**DEVIATION REQUEST
AND DECISION FORM**

Project Name : Willow Springs Ranch Filing No. 1
 Schedule No.(s) : 7126000035, 7126000041, 7127000003
 Legal Description : Forest Lakes Drive, between Hay Creek Road and Cattail Drive

Figure 2
Site Plan

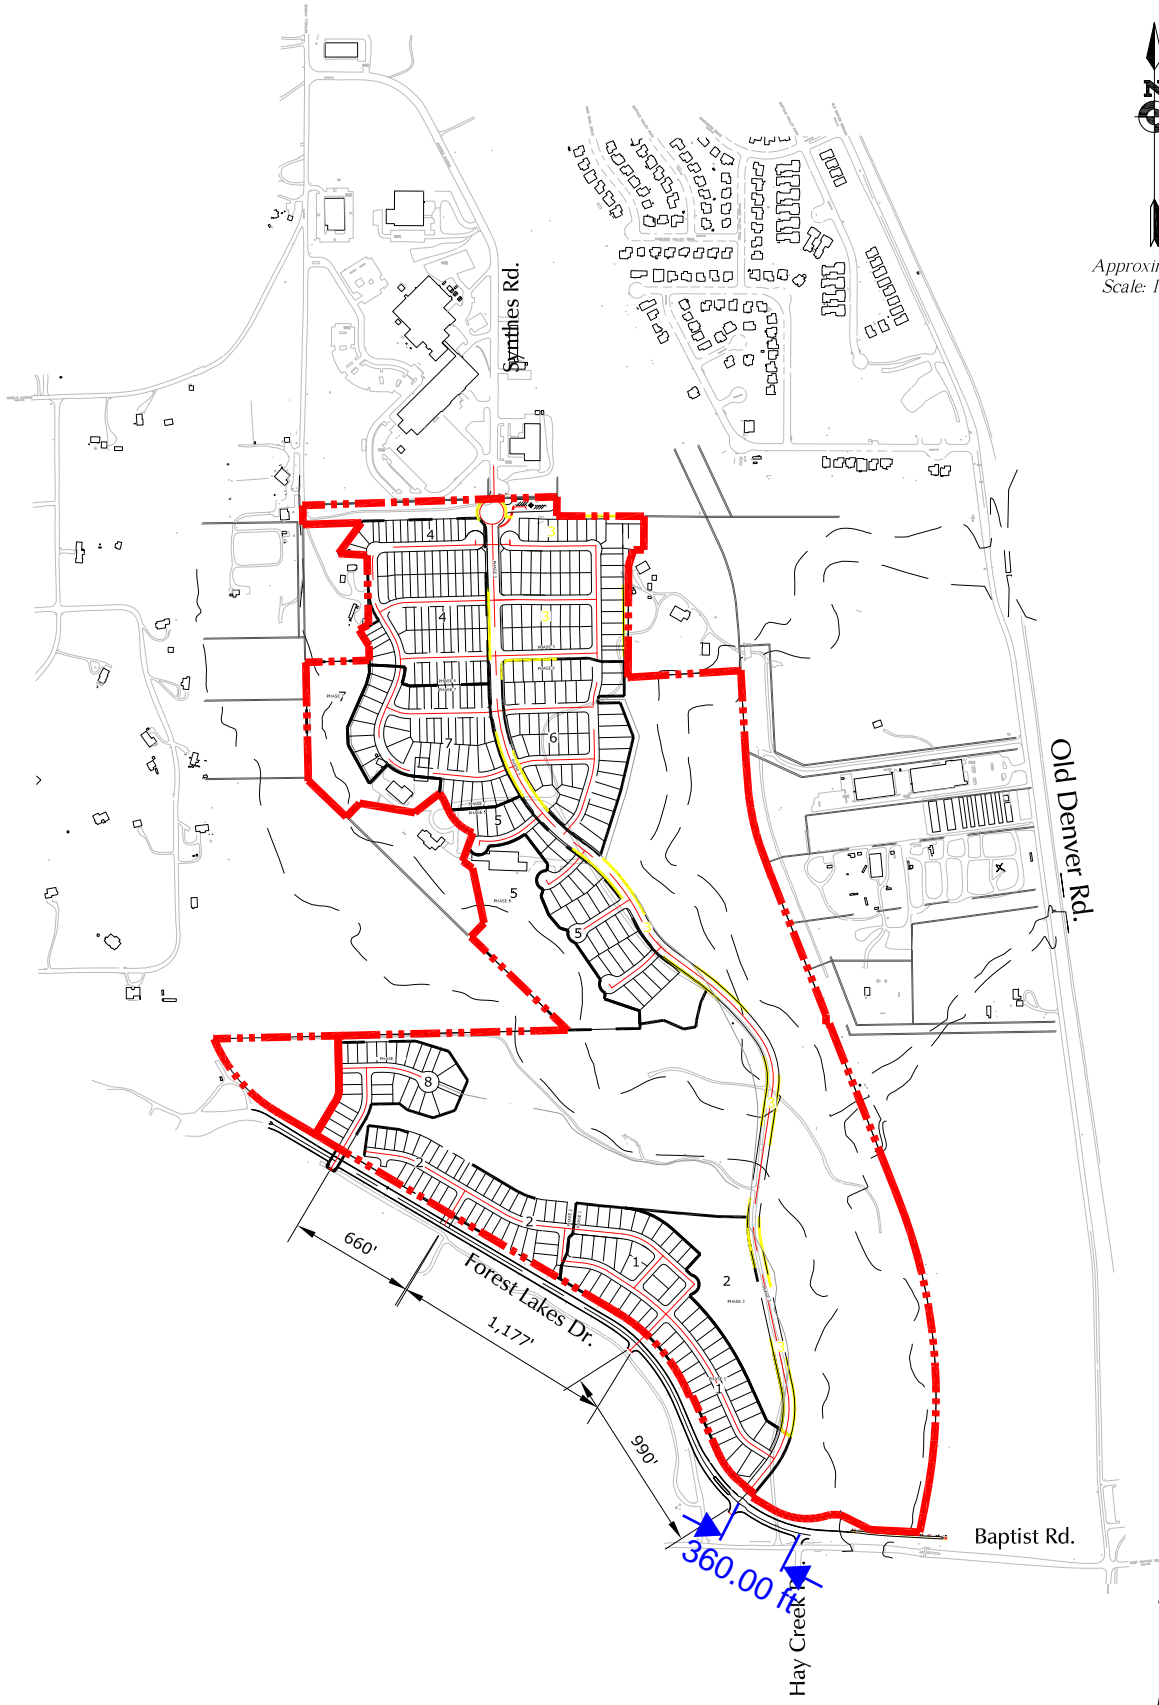
Minimum intersection spacing on an urban collector of 660' is the standard. The deviation is requested for spacing of ~360' between the proposed Willow Ranch Drive and Hay Creek Road to the east. To the west, the next intersection is with Pelican Bay Drive at ~1000' spacing.

This request has been determined to have met the criteria for approval. A deviation from Section _____ of the ECM is hereby granted based on the justification provided.

An access permit will be required between the Town of Monument and El Paso County prior to approval of a work in the ROW permit.
